**Subject:** RE: New Tree Review Status for 2009 Lakeshore Dr. - 2016-156405 TP

# Tree Ordinance Review Application

LAKE SHORE RESIDENCE  
Board of Adjustments

## NEW FRONT YARD LOCATION PER CITY OF AUSTIN

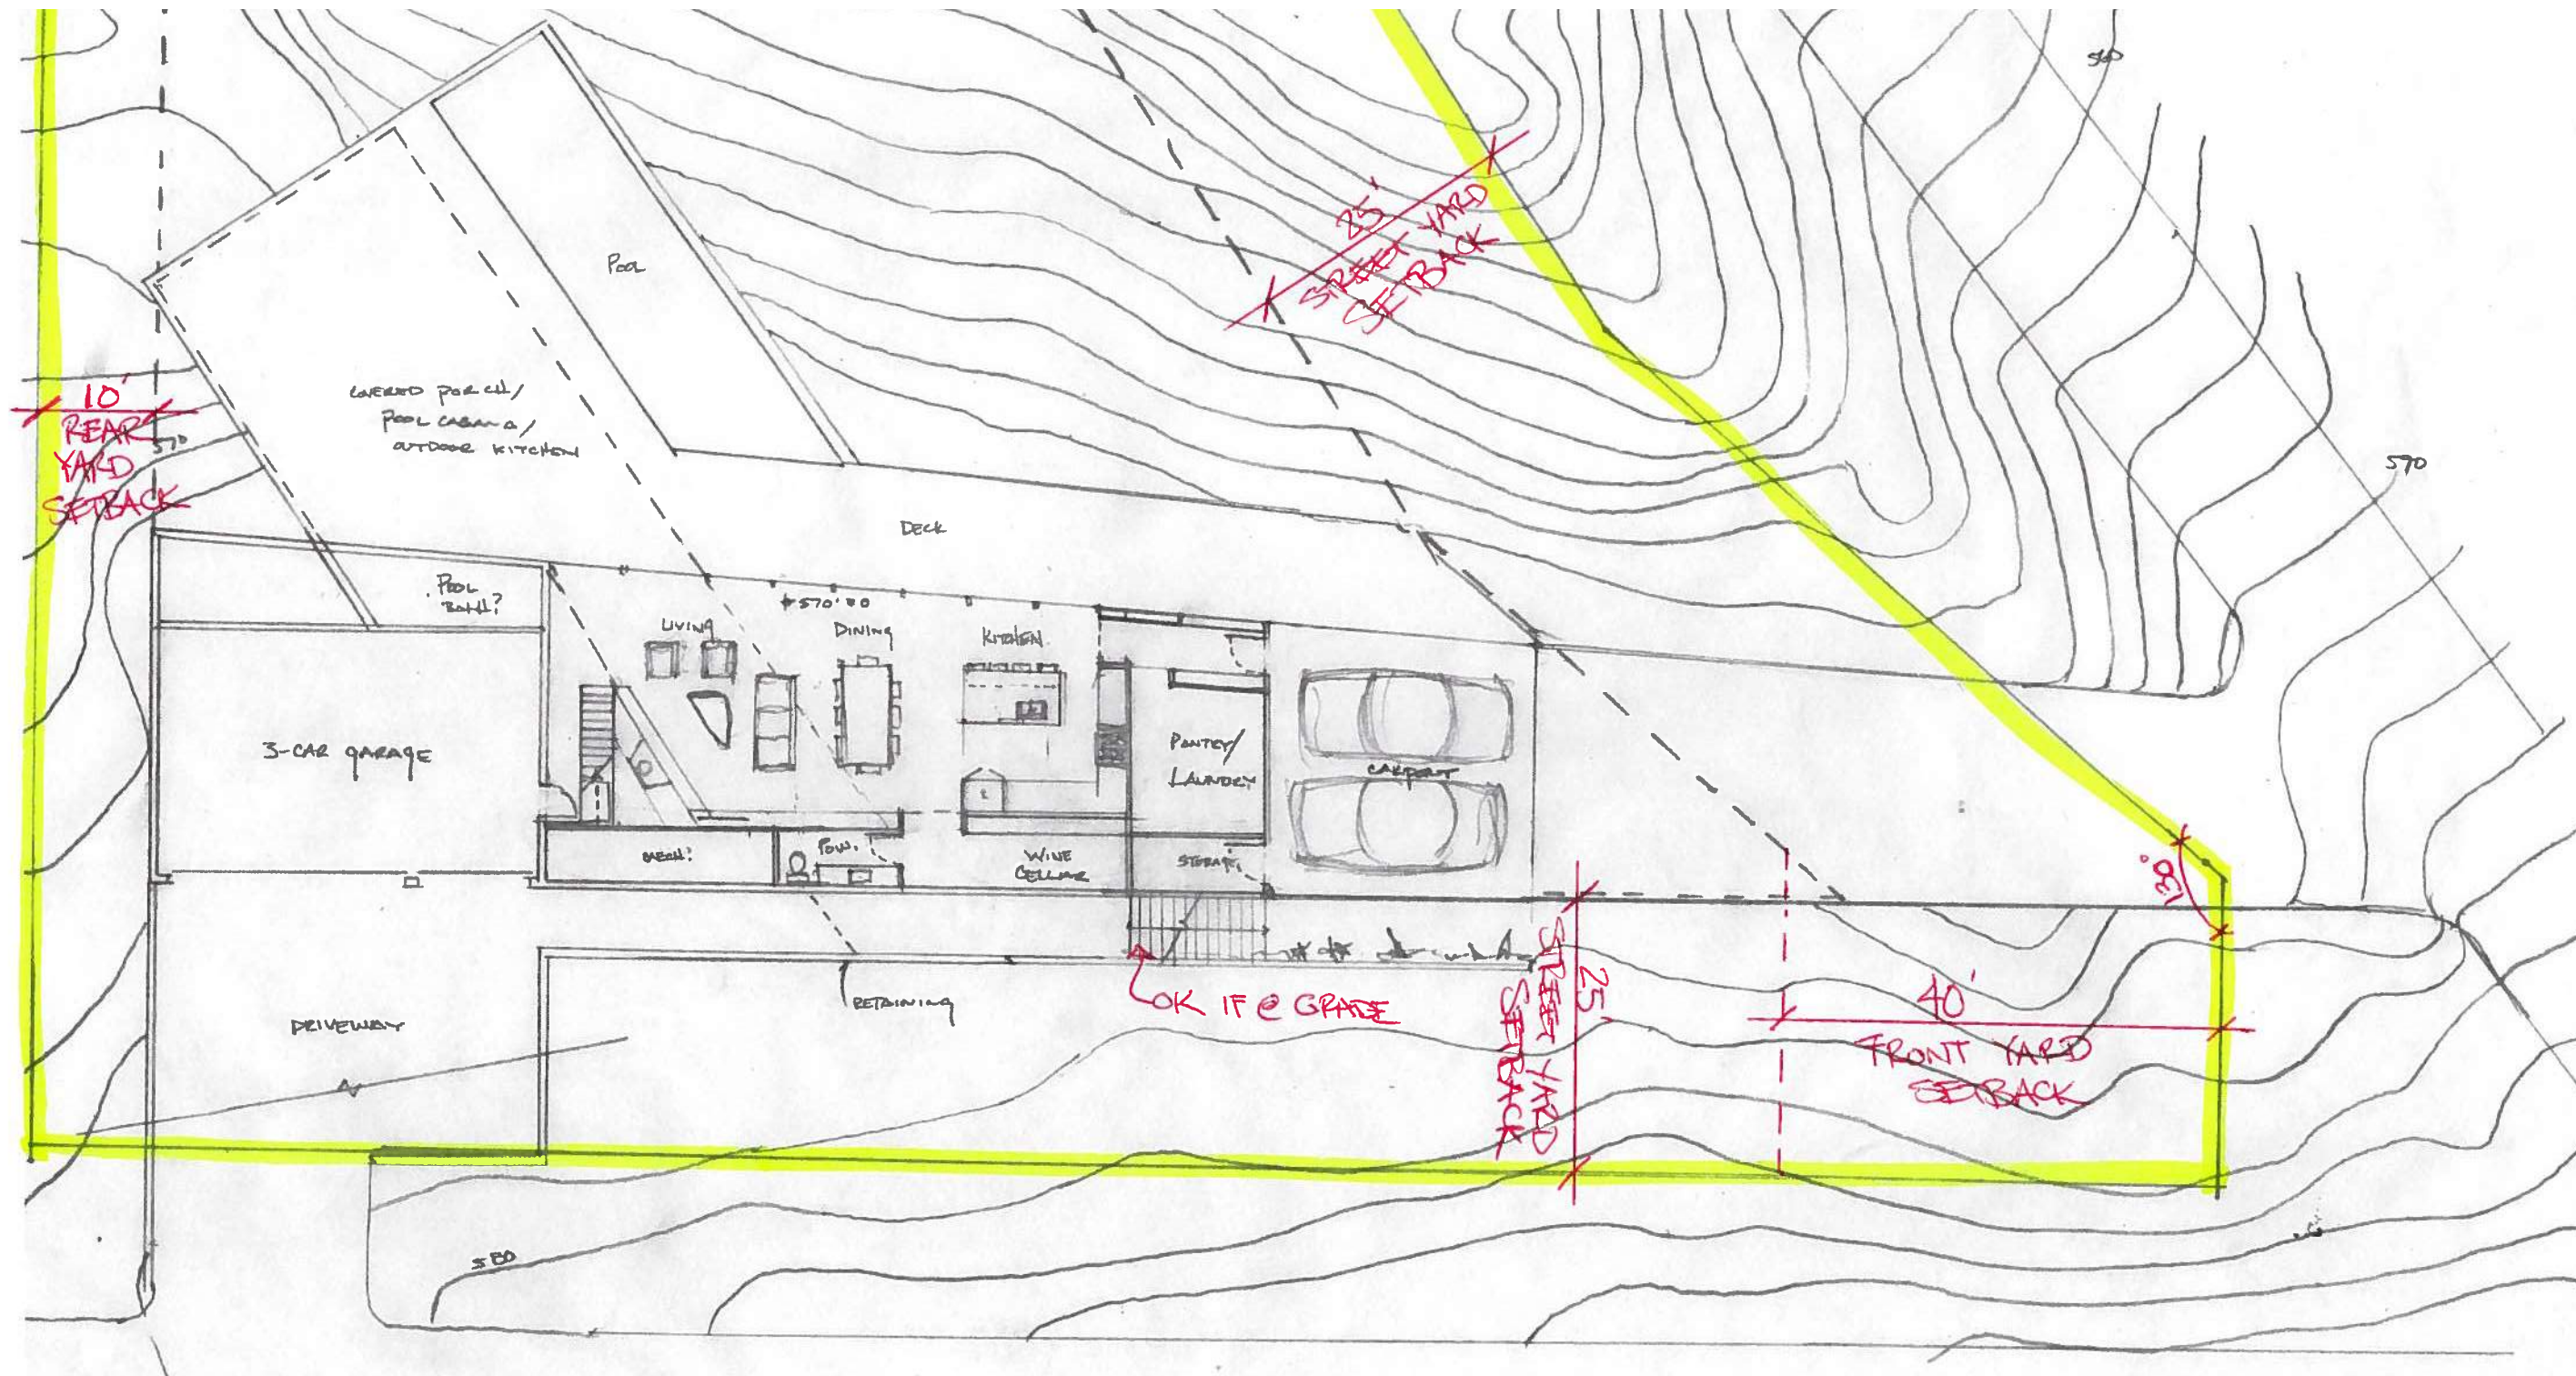
“Since the angle between L2 and the adjacent property line parallel to Island Way is  $<135^\circ$ , L2 is the front property line. As such, its setback is 40'. The setback from each respective street is 25'. However, with L2 being the front property line, the interior property line is then the rear property line requiring a 20' setback. If a 10' setback is desired, a BOA variance will need to be sought.”
